UNITED STATES PATENT AND TRADEMARK OFFICE

APPLICATION NO.	FILING DATE	FIRST NAMED INVENTOR	ATTORNEY DOCKET NO.	CONFIRMATION NO.
10/779,864	02/18/2004	Edwin Eduard Nicolaas Josephus Krijnen	081468-0308328	6215

Office Action Summary

DETAILED ACTION

Figure 1: Schematic view of the SCMM (one axis shown)

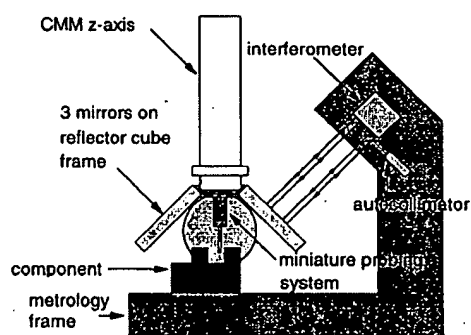
With regard to claim 1, Peggs et al teach a method of determining the displacement of an object in an apparatus along the z-direction(Fig. 1):

acute angle with said z-direction, said measuring laser beam being substantially retro-reflected and at least partly overlapping said reference beam to provide an interference signal(Fig's 1,2; the reflector cube mirror);

Peggs et al teach mounting a measurement mirror on an object to measure displacement along the Z-axis, a line normal to the measurement mirror having a non-zero acute with the Z-axis; and perpendicularly directing the measurement beam from an interferometer on the measurement mirror, see figure 1.

The motivation for this modification is shown in Peggs et al, figure 1. With this configuration the number of parts in the system is reduced, mirror 35 is

Figure 2: Optical scheme of the interferometers

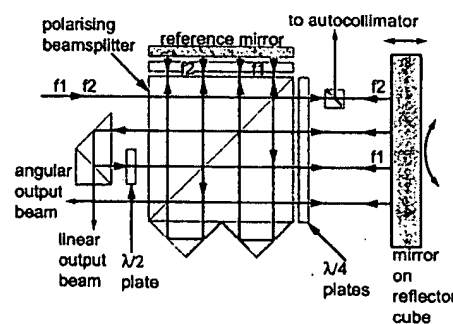
providing a reference laser beam(Fig. 2, f1);

a laser beam generator system configured to generate at least one reference laser beam and at least one measuring laser beam(Fig. 2; f1,f2);

providing said reference laser beam and said measuring laser beam such that said measuring laser beam is directed towards said measuring mirror in a direction substantially perpendicular to said mirror surface and said measuring laser beam is substantially retro-reflected by said measuring mirror to at least partly overlap said reference beam to generate said interference signal(Fig.2; the linear output beam);

With regard to claim 17, it would have been obvious to one of ordinary skill in the art at the time the invention was made to modify Ulaji with the specific laser interferometer of Peggs et al. The laser interferometer of figure 2 in Peggs et al is a known heterodyne interferometer from Zygo. It provides a first measuring beam f2 which measures linear displacement when interfered with reference beam f1. A second parallel measurement beam, now f1, is incident on the measurement mirror and a measurement of angular displacement is obtained when beams f1 and f2 are again interfered.

FIG. 2

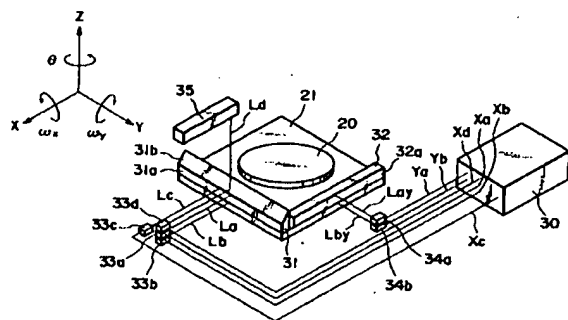
With regard to claim 7, Ukaji teaches a method of determining the displacement of an object in an apparatus along the z-direction, said object having a surface which extends substantially in a plane perpendicular to said z-direction and which is illuminated by a beam of radiation having an optical axis extending along the z-direction, said method comprising(Fig's 2,3):

an interference signal processing system, arranged and constructed for receiving an interference signal produced by said reference beam and said measuring beam and for determining a displacement on the basis of a change in said interference signal(Fig. 2, 30);

providing an interferometer system comprising(Fig. 2; 33d):

an interference signal processing system configured to receive an interference signal produced by said reference laser beam and said measuring laser beam, and to determine said displacement based on a change in said interference signal(Fig. 2, 30);

As to claim 14/8, further comprising an additional displacement measuring system configured to determine at least one additional displacement in at least one additional direction, wherein said interference signal processing system has been arranged and constructed to use said additional displacement in determining the displacement of said object in the z-direction(Fig. 2, 33a; column 6, line 58- column 7, line 4).

FIG. 3

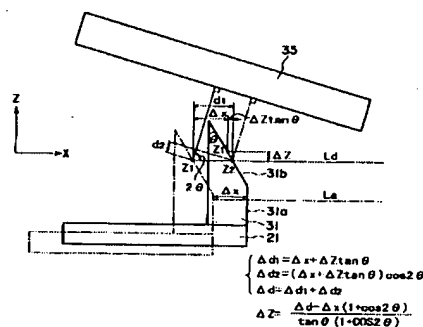
a set of at least two mirrors comprising at least one mirror which is a measuring mirror fixedly connected to said object and having a mirror surface in which a reference line normal to the mirror surface makes a non-zero acute angle with said z-direction(Fig. 3, 31b), and

at least one separate mirror having a fixed position with respect to said apparatus(Fig. 3, 35);

Ukaji uses a combination of mirrors 31b and 35 in the measurement path, and fails to teach wherein the measurement beam is directed substantially perpendicularly onto mirror 31b.

at least one mirror, wherein said at least one mirror includes a measuring mirror with a fixed position relative to said object and having a mirror surface in which a reference line normal to the mirror surface makes a non-zero acute angle with said z-direction(Fig. 3, 31b);

As to claim 3/2, wherein said measuring mirror is arranged such that said normal to said measuring mirror contains an angle α with respect to the z-direction, wherein α is between approximately 60° and about 87° (Fig. 3; column 7, lines 5-8). The angle 2θ is defined as the angle between the incident beam and the line normal to the mirror 35 which has a range of: $0^\circ < 2\theta < 90^\circ$. Because the angle of incidence is equal to the angle of reflection, the angle between the incident beam and the line normal to the mirror 31b is θ . Basic geometry defines the angle between the Z-axis and the line normal to the mirror 31b as $90^\circ - \theta$ which is applicant's angle α . Therefore, as 2θ approaches 0° angle α will approach 90° . This will include the range of 60° to 87° .

- a movable holder configured to hold said object(Fig. 3, 21); and

- at least one mirror, wherein said at least one mirror includes a measuring mirror with a fixed position relative to said object and having a mirror surface in which a reference line normal to the mirror surface makes a non-zero acute angle with said z-direction(Fig. 3, 31b); and

FIG. 6

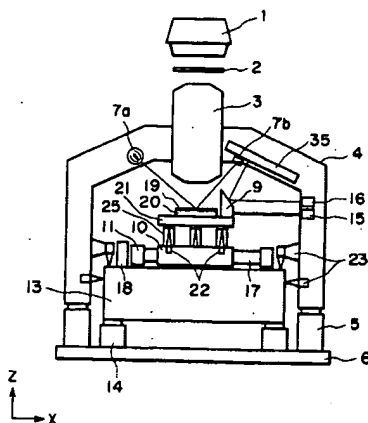
With regard to claim 8, Ukaji teaches a lithographic apparatus (Fig. 6), comprising:

- a projection system configured to provide a beam of radiation for illuminating an object(Fig. 6, 1-3), said beam of radiation having an optical axis in a z-direction;

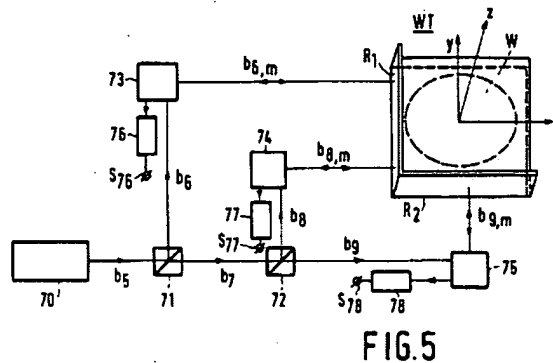
Yamasaki et al teach an alignment mark(Fig. 5, FM) located on the stage and separate from the wafer is used to determine Abbe error for the interferometer system when the optical axis of said beam of radiation is at the image position of the alignment mark(column 15, line 58- column 16, line 19).

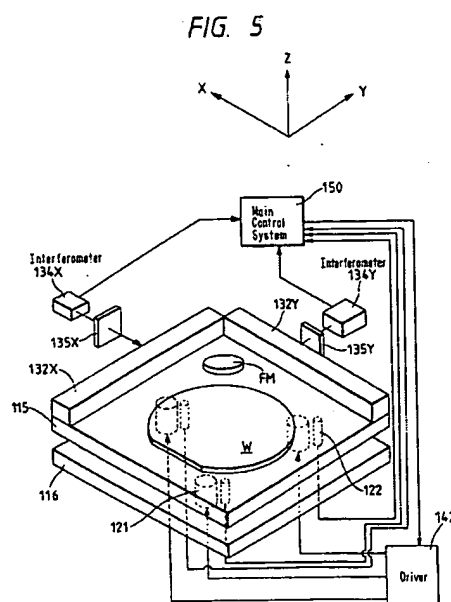
Van Den Brink teaches that all the interferometers in a lithographic projection system can share a common source(Fig. 5, 70).
